**Subject: Dresden Nuclear Power Station Unit 2
 Systematic Evaluation Program (SEP) Status
 NRC Docket No. 50-237**

Dresden Nuclear Power Station Unit 2
SEP Topic III-1

Classification of Structures, Components,
and Systems (Seismic and Quality)

Figure 1 Two-Dimensional Axisymmetric Finite Element Model Geometry

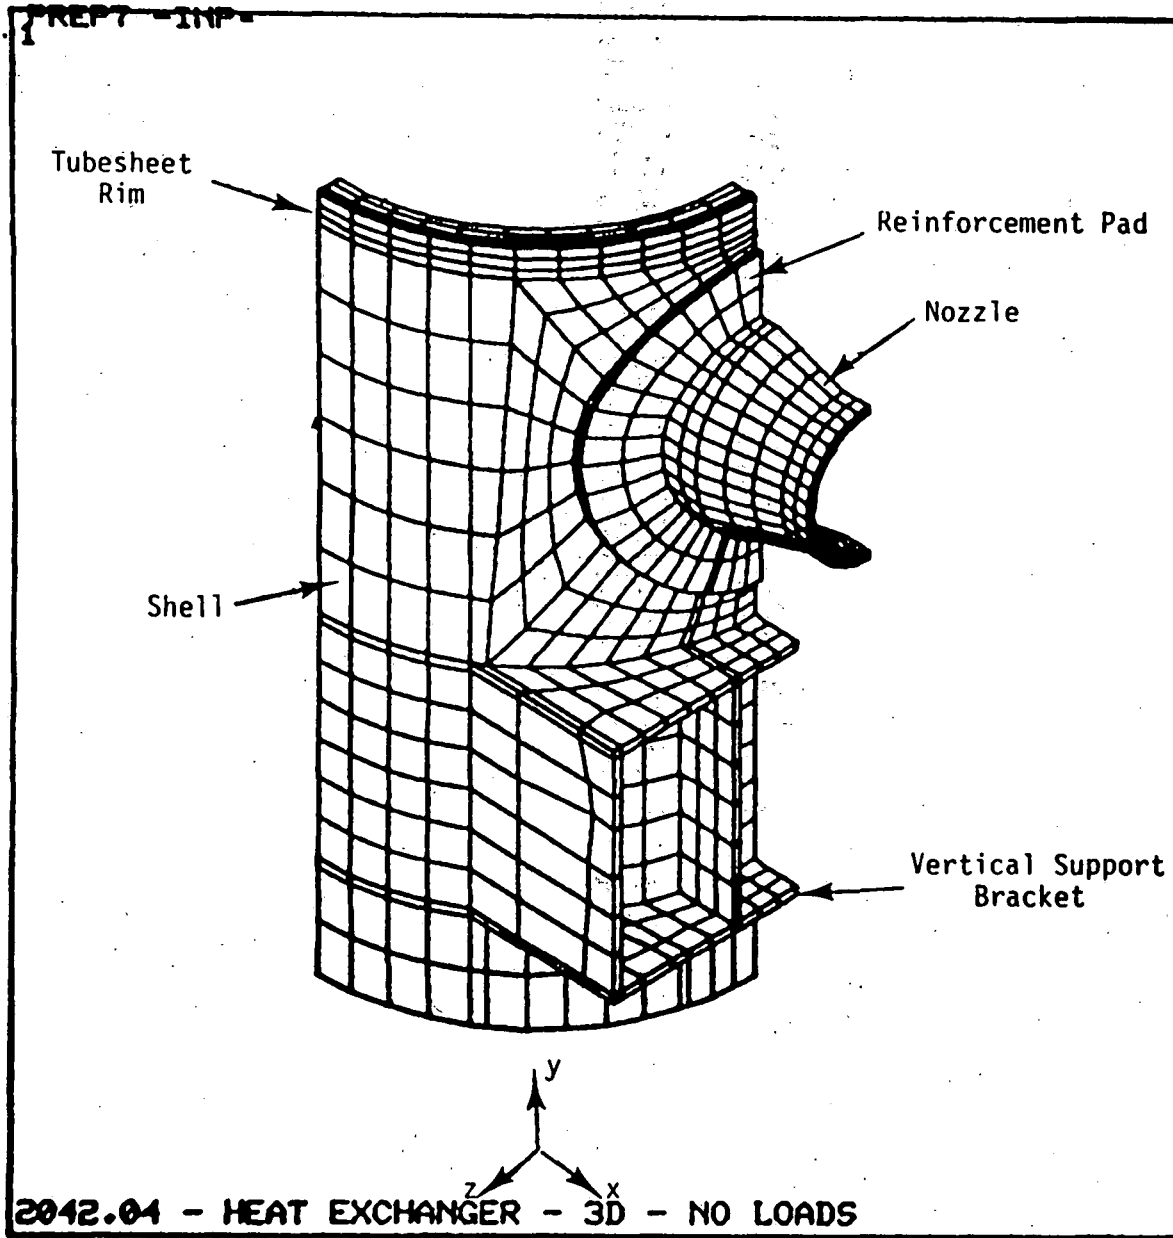
The 2-D model includes the tubesheet, the head, the tubes, the closure studs and one-half of the shell barrel (see Figure 1). Analyses that were performed using this model include the structural (internal tube side and shell side pressures and bolt preload) and thermal load conditions that the HX is subjected to. The 3-D model includes the shell side outlet nozzle, the nozzle reinforcement pad, the vertical support bracket, the tubesheet rim and the shell barrel (see Figure 2). This model represents the most highly stressed region of the HX. Displacements calculated by the 2-D model were applied to the detailed 3-D model at nodes which represent common locations in the two models.

Figure 3 Material Toughness

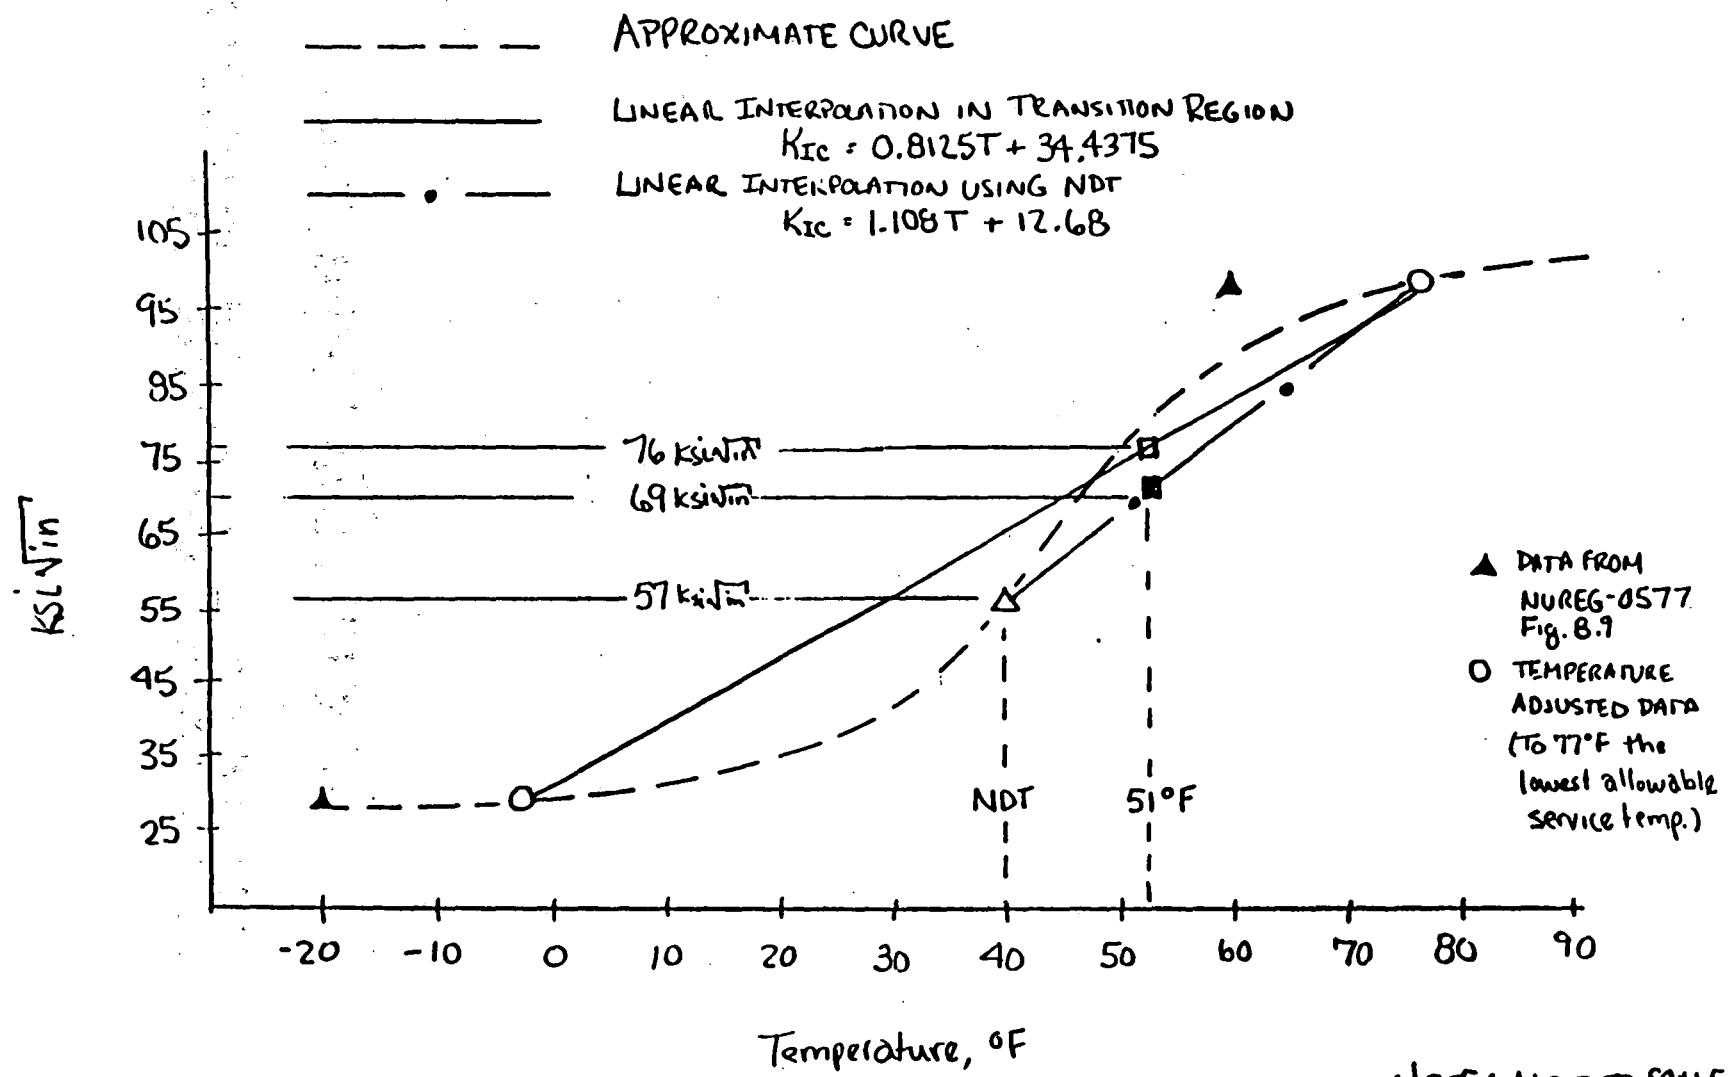
To relate this information to the average nil ductility temperature (NDT) of 40°F, K_{IC} was calculated per the procedure in Rolfe and Barsom, Fracture and Fatigue Controls in Structures, Sec. 6.4, herein referred to as Reference 1. The straight line between this value, 57 ksi $\sqrt{\text{in}}$, and the adjusted upper bound of the transition region, 98 ksi $\sqrt{\text{in}}$, could also be used to conservatively evaluate K_{IC} at 51°F as indicated on Figure 3. It was judged that this K_{IC} value of 69 ksi $\sqrt{\text{in}}$ is unnecessarily conservative, so the 76 ksi $\sqrt{\text{in}}$ was used in the fracture mechanics evaluation. However,

it is apparent from the extremely long calculated fatigue life discussed below that the 69 ksi \sqrt{in} material toughness would also have been adequate.

Figure 4a

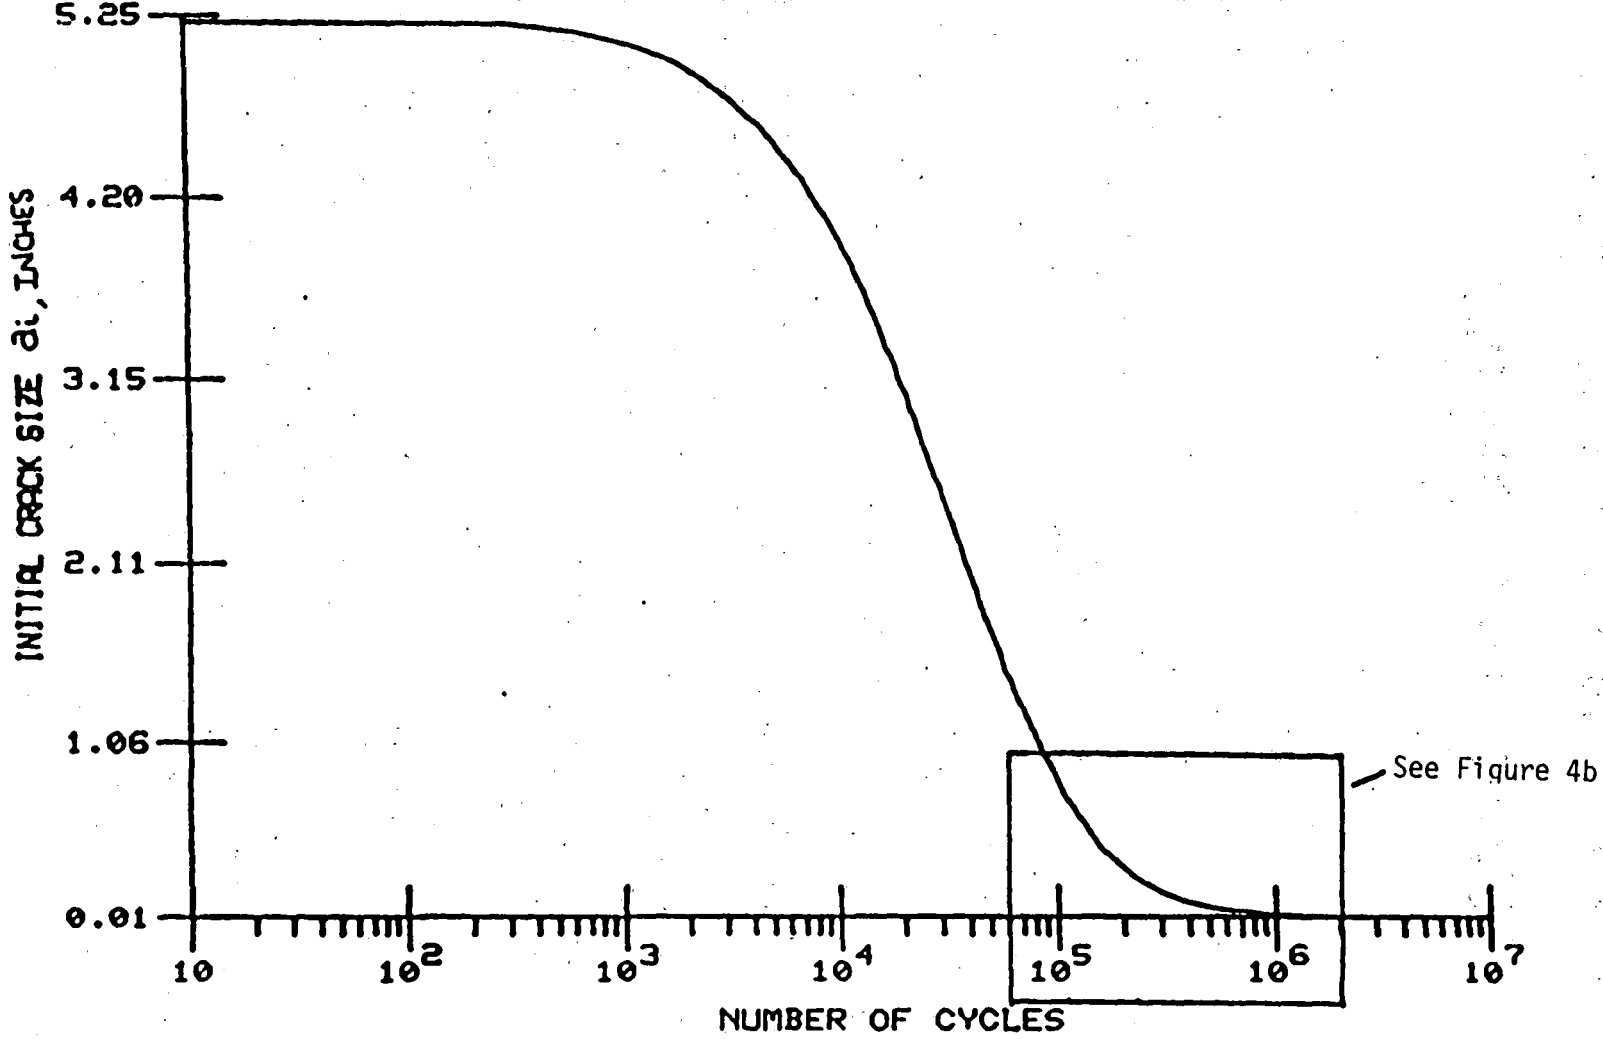
For the calculated maximum principal stress, 16.7 ksi, from the 3-D analysis, the critical crack size is 5.25 inches. Using the maximum stress range and the crack growth rate equation from p.234 of Reference 1, the number of cycles, N, required for various assumed initial crack sizes, A_i , to grow to the critical crack size, A_{cr} , is calculated. See Figures 4a and 4b for plots of A_i vs. N for the LPCI-HX.

It was concluded, based upon an initial crack size of .010 inch (chosen as the maximum crack size that could go undetected by inspection of the unit at the time of its construction) and a cold shutdown temperature of 51°F, that the number of cycles that would be required to propagate a crack of this size to the critical crack size is approximately 1.5×10^6 . Based solely from this fracture mechanics analysis and a system startup and shutdown cycle occurring on an average of once a month, the acceptable number of cycles is far beyond any anticipated service life of the LPCI-HX as well as several orders of magnitude beyond the maximum conceivable plant lifetime including life extension. Therefore, the fracture toughness of the shell side of the LPCI-HX would be more than adequate.
